Northern Link Road Tunnel Project

## **Application for Project Change**

October 2010

Figure 2-7: Reference Design Western Connection – Centenary Motorway connection

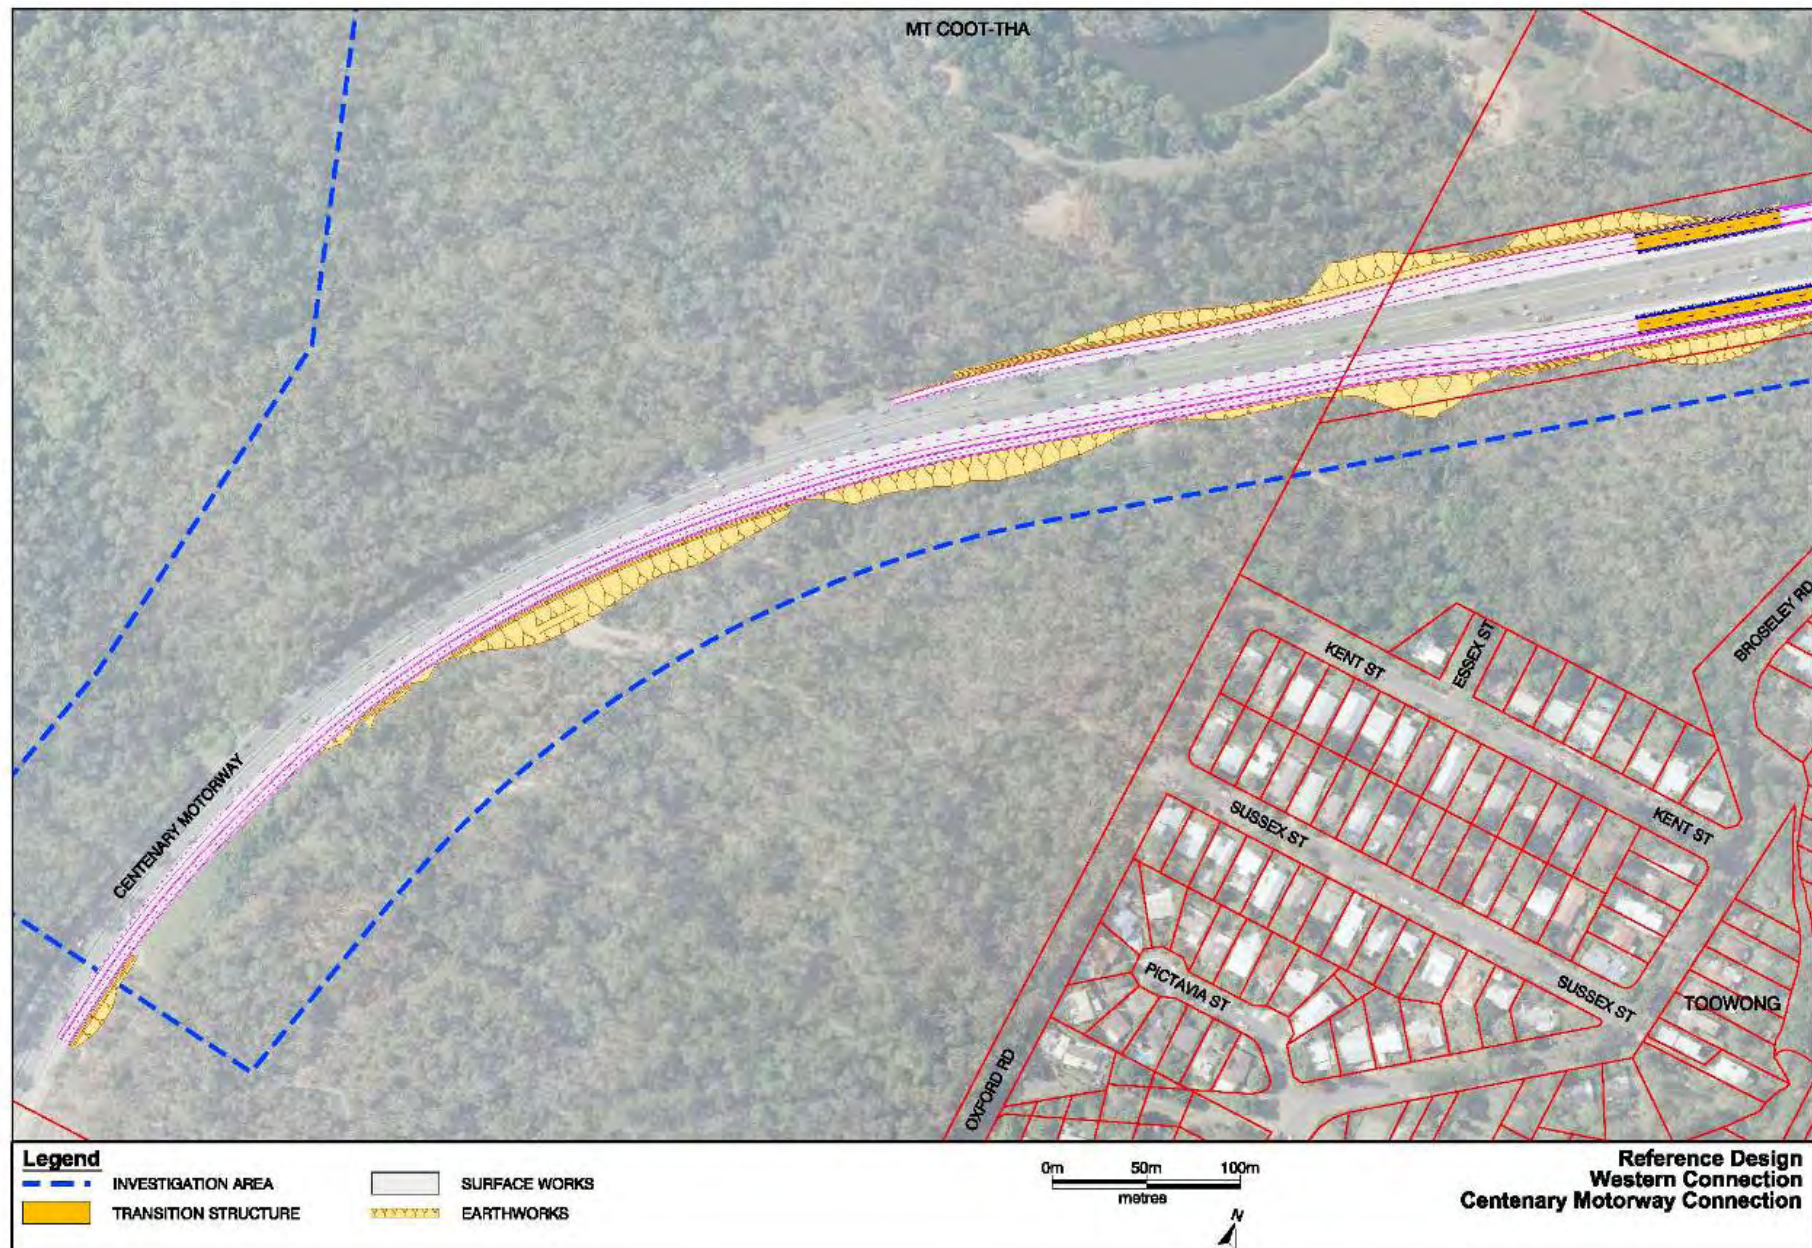
Design Element	Description of the Reference Design (RD)	Description of the proposed Change	Reason(s) for Change
locations	the Motorway to the tunnel of approximately 175m  Refer to drawing <b>Figure 2-7</b> and Supplementary Report Volume 2 Planning Layouts <sup>1</sup>	Motorway of approximately 650m and a diverge of approximately 375m.  Refer to <b>Figure 2-8</b> and <b>Figure 2-17</b>	vertical geometry. The longer (200m) diverge is due to the improved geometry and to comply with agreed design standards.
Western ventilation and infrastructure maintenance access.	Ventilation station and associated facilities partially buried into the higher ground at the western end of the western worksite. Access not defined.  Refer to <b>Figure 2-5</b> and Supplementary Report Volume 2 Ventilation Site Plans <sup>4</sup>	Ventilation station fully buried. The ventilation outlet has moved approximately 43 metres north west, which is further away from the nearest residence. A water and power utility area would remain cut into the higher ground with final access arrangements to be approved by DTMR. No change to the minimum height of the ventilation outlet.  Refer to <b>Figure 2-31</b> and <b>Figure 2-38</b>	There is no change to ventilation outlet minimum level. The reason for the decision to fully bury the ventilation station was to further reduce visual impact from within the Botanic Gardens. The change in the location of the ventilation outlet is as a result of the burying of the ventilation station in order to mitigate visual impact.

Figure 2-14: Changed Project Eastern Connection – Tunnel Portals

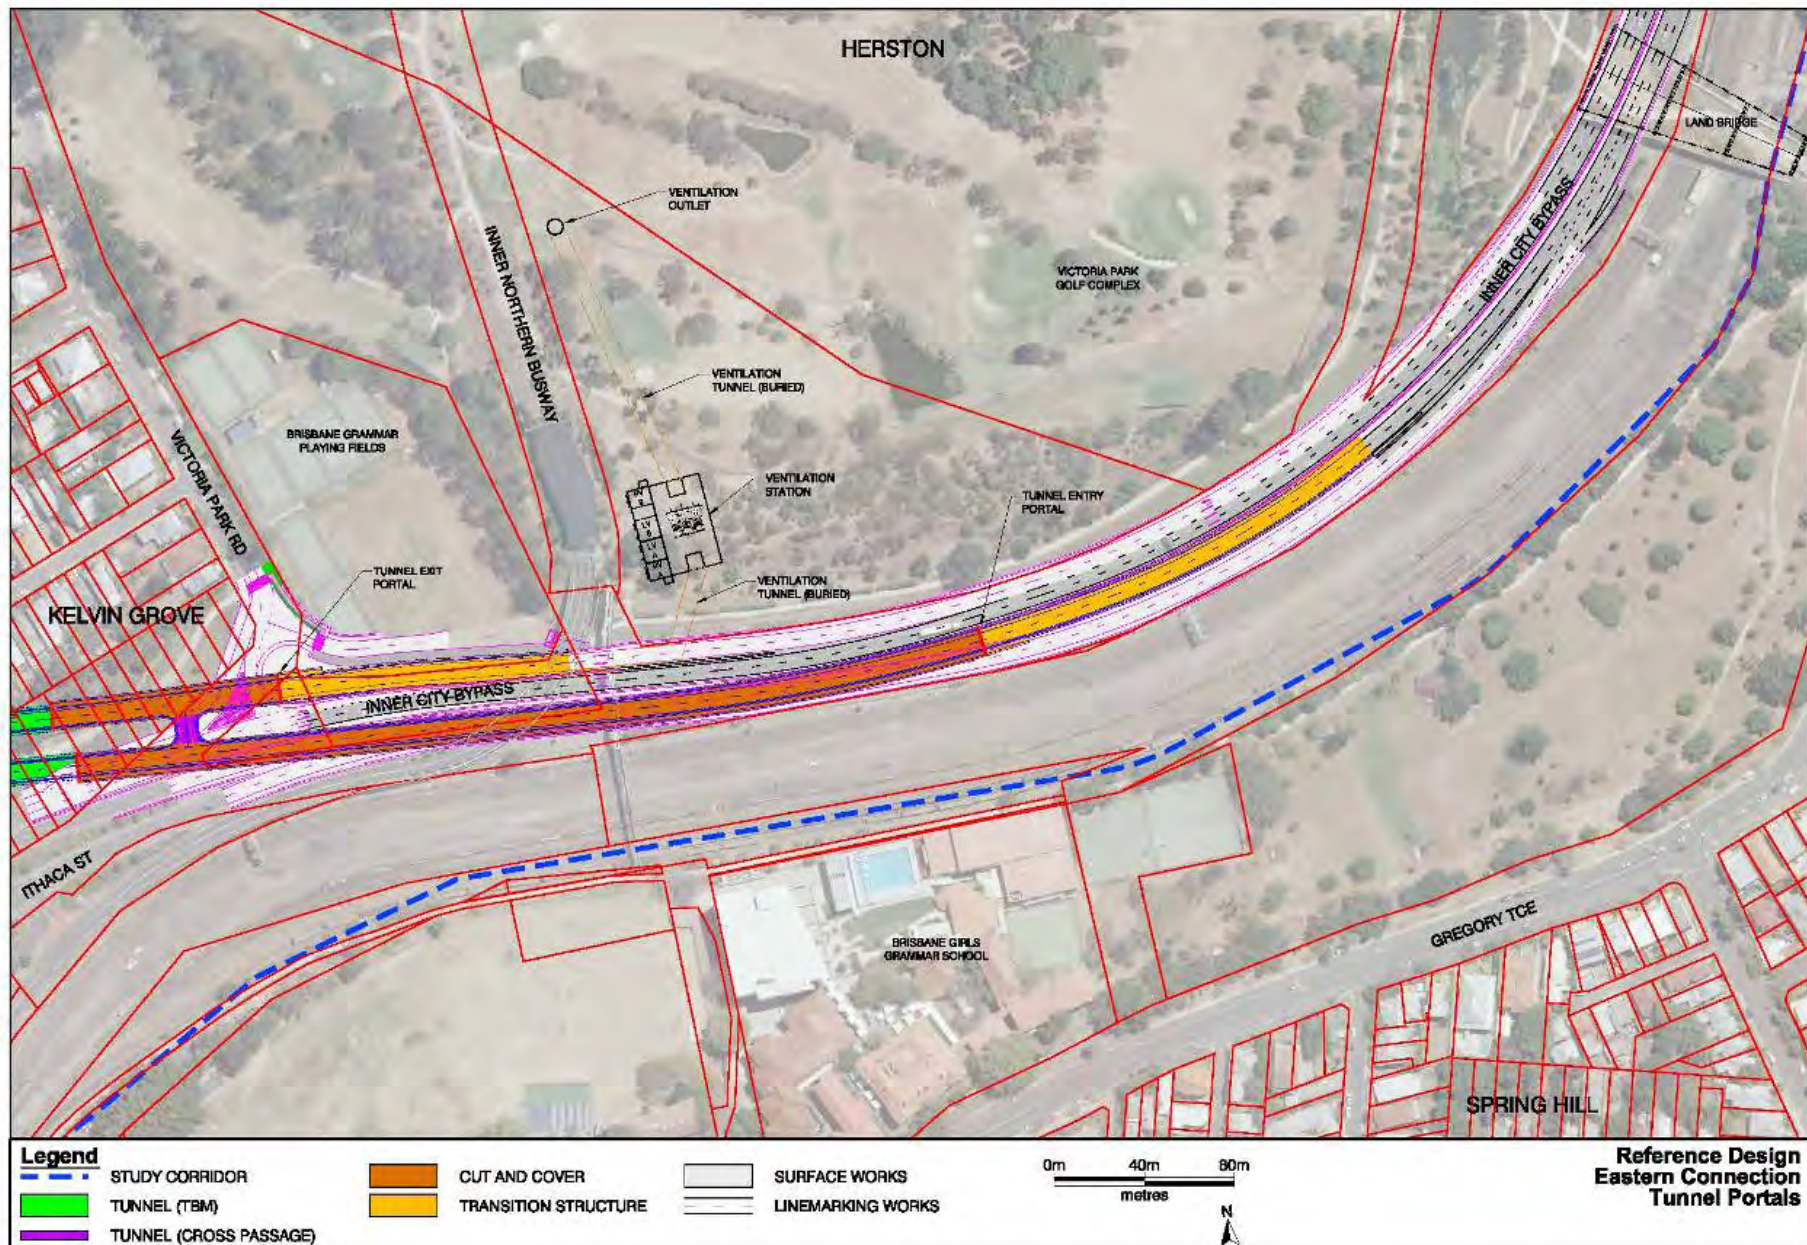
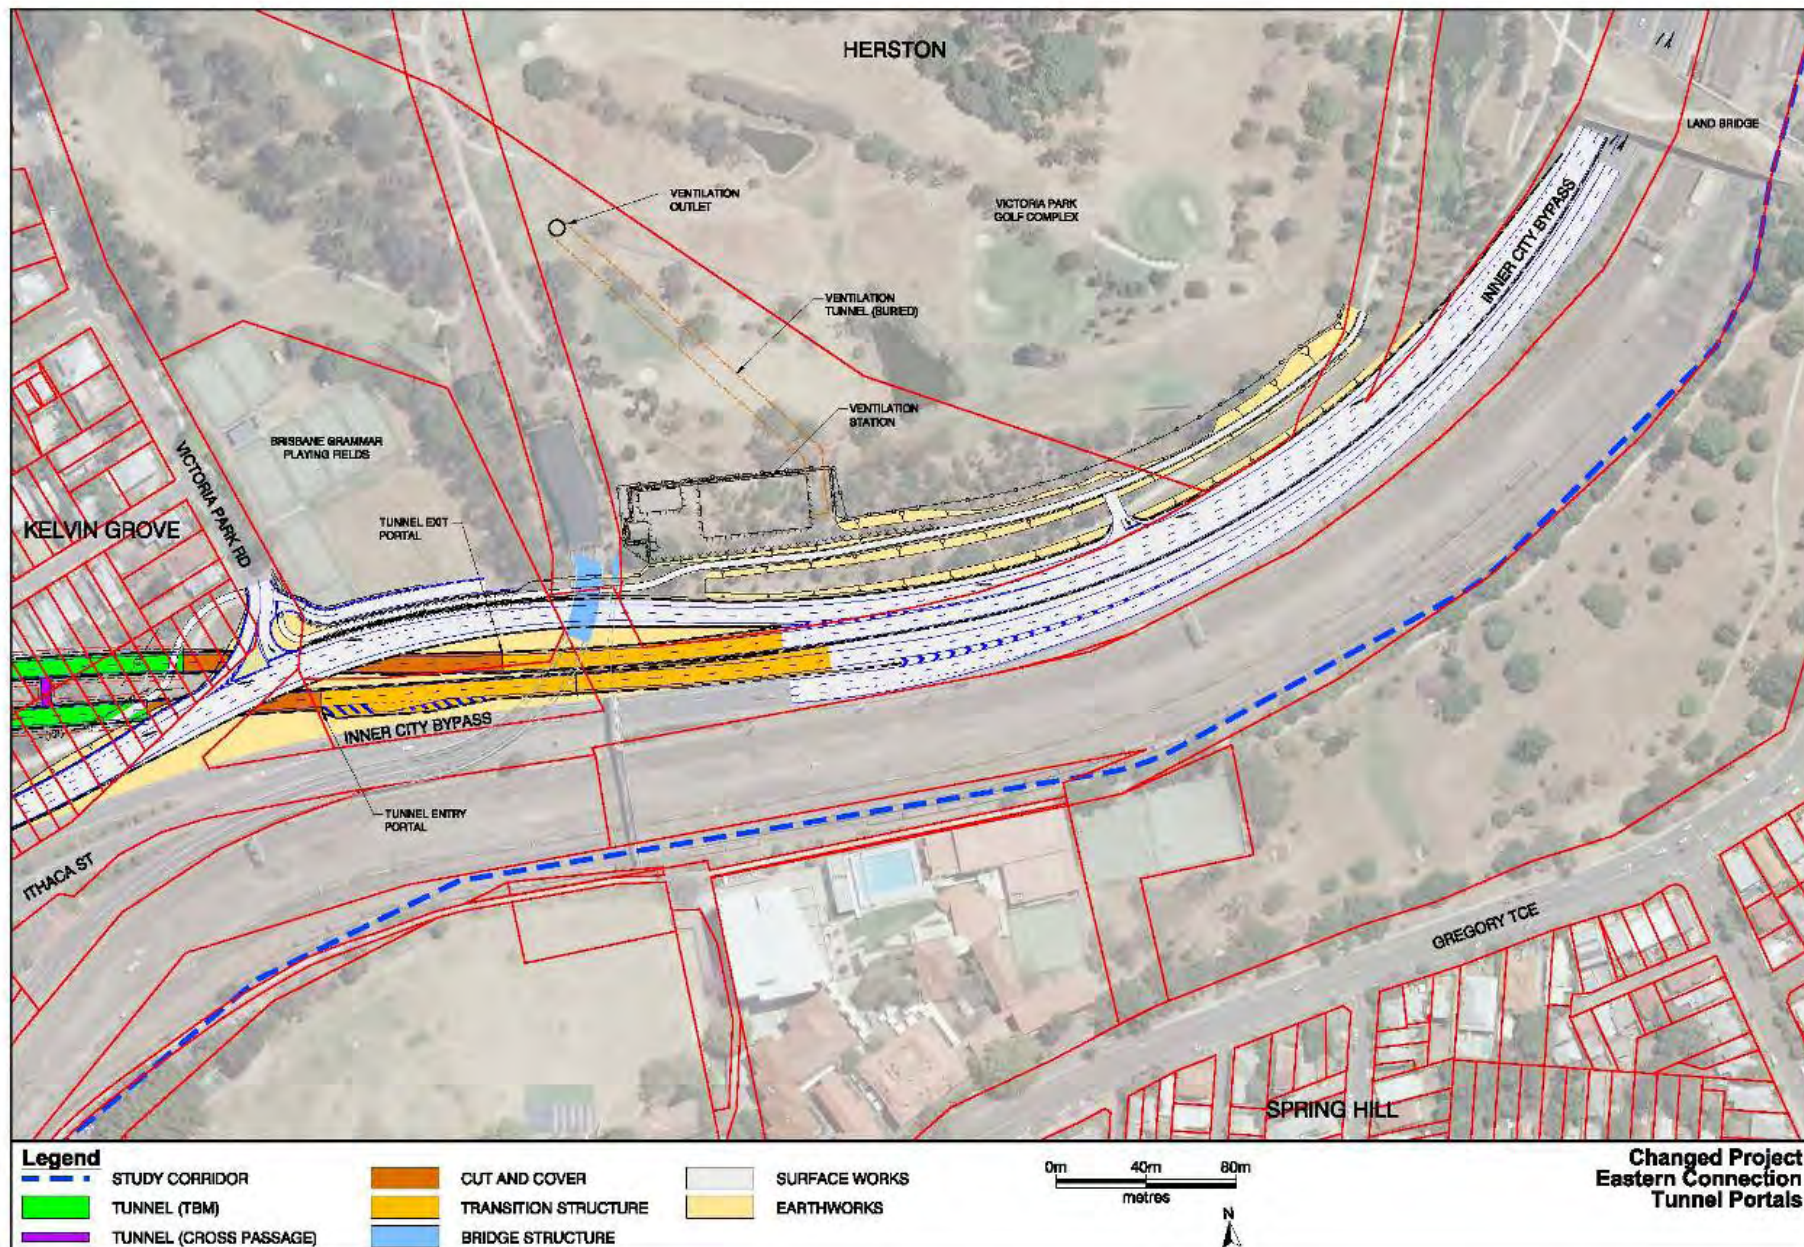
Cut and Cover tunnels and tunnel entry and exit portal locations	Westbound entry portal located in line with the eastern side of the Brisbane Girls Grammar School with cut and cover approximately 406m long through the westbound lanes of the ICB Eastbound exit portal located in line with Victoria Park Road some 100 m east of the TBM portal	Westbound entry portal located 300m further west in line with Victoria Park Road. Eastbound exit portal located 60m east to the western side of the INB overpass. Tunnel portals located together and within the centre of the ICB  Refer to <b>Figure 2-14</b> and <b>Figure 2-37</b>	Significantly reduces the impact of the works on ICB traffic during construction by some 330m of cut and cover through the westbound lanes of the ICB

Design Element	Description of the Reference Design (RD)	Description of the proposed Change	Reason(s) for Change
	Refer to <b>Figure 2-13</b> and Supplementary Report Volume 2 Planning Layouts		
Tunnel entry and exit transition ramps to the ICB	<p>Eastbound transition exit ramp from Victoria Park Road portal to the INB Busway. Westbound transition entry ramp from the eastern side of the Brisbane Girls Grammar School (BGGs) for approximately 190m</p> <p>Refer to <b>Figure 2-13</b> and Supplementary Report Volume 2 Planning Layouts<sup>1</sup></p>	<p>The transition ramps for the Changed Project have also been brought together from a position in line with the middle of BGGs to the tunnel portals between Victoria Park Road and the INB overpass.</p> <p>Refer to <b>Figure 2-14</b> and <b>Figure 2-37</b></p>	Due to changes in the positions of the cut and cover tunnels due to the realignment of the ICB in order to create off-line construction conditions with significantly reduced traffic impacts and also better sight lines for merge and diverge conditions.

Eastern ventilation and other infrastructure and maintenance access.	<p>Location to the east of the INB with no urban design or access identified.</p> <p>Refer to <b>Figure 2-13</b> and Supplementary Report Volume 2 Ventilation Site Plans<sup>4</sup></p>	<p>Urban design developed and controlled access identified off the eastbound carriageway of the ICB</p> <p>Refer to <b>Figure 2-37</b> and <b>Figure 2-39</b></p>	<p>No change to the general location.</p> <p>Further development of the project design to identify urban design and maintenance access.</p>
